Replacement of Fisher™ DSV High-Performance Digester Switching Valve with Fisher 8580 Valve and 2052 Actuator

Management of Change

Figure 1. Actuator Mounting Pad Dimensions

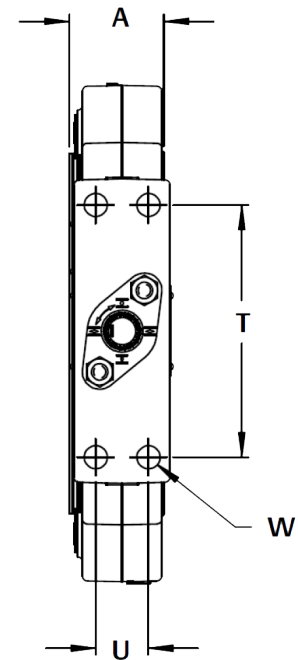
Shaft Size and Actuator Mounting

The DSV and 8580 valves have the same shaft size and actuator mounting dimensions. The actuator portion of the DSV package could be re-used on an 8580 valve, however the actuator sizing would need to be confirmed.

T (Indicated in Figure 1)		U (Indicated in Figure 1)	
		DSV	8580	DSV	8580
NPS 4	mm	152	152	32	32
	in	6.00	6.00	1.25	1.25
NPS 6	mm	152	152	32	32
	in	6.00	6.00	1.25	1.25
NPS 8	mm	235	235	46	46
	in	9.25	9.25	1.81	1.81
NPS 10	mm	235	235	46	46
	in	9.25	9.25	1.81	1.81
NPS 12	mm	235	235	46	46
	in	9.25	9.25	1.81	1.81
